CITY OF CONWAY, ARKANSAS HISTORIC DISTRICT COMMISSION

HISTORIC DISTRICT COMMISSION

A. New single-family residence at 611 Walnut St (HDR-0625-0074) OLD BUSINESS

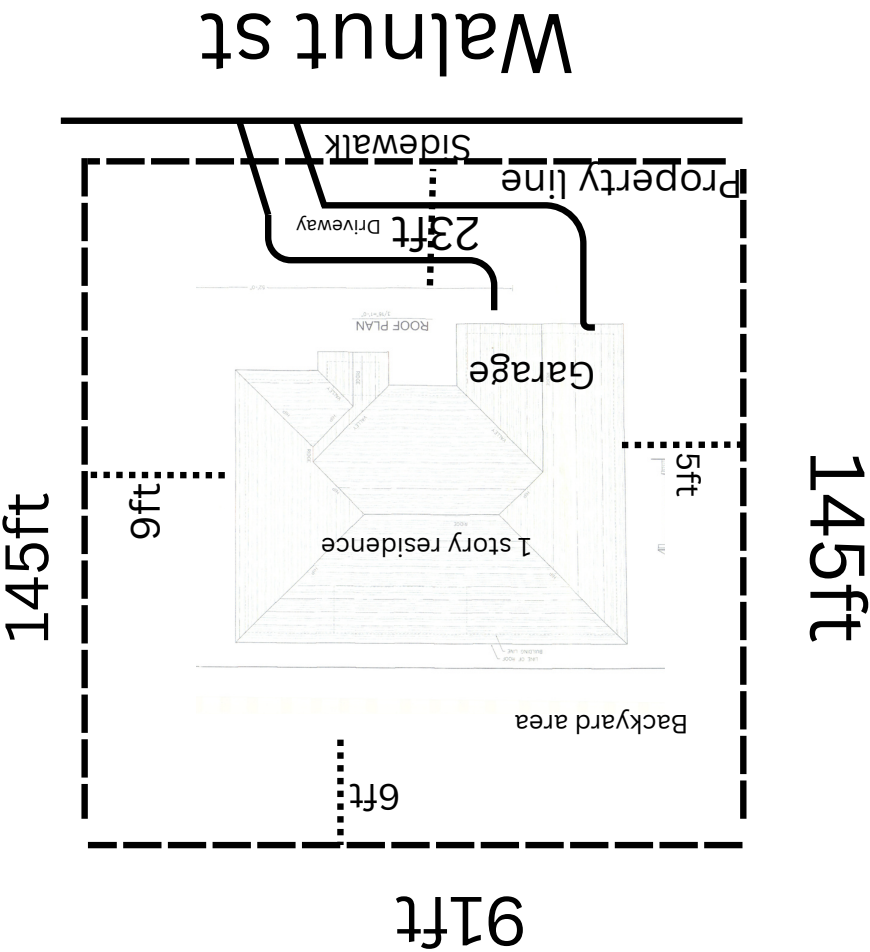
Mechanical System Screening. HVAC units should be located where they are not readily visible from the street. If visible, they should be screened with shrubbery or fencing.

No HVAC equipment is shown on the site plan.

8. HVAC equipment shall be shown on the site plan and screening proposal indicated.
9. Authorization of agent form shall be submitted prior to issuance of building permits.
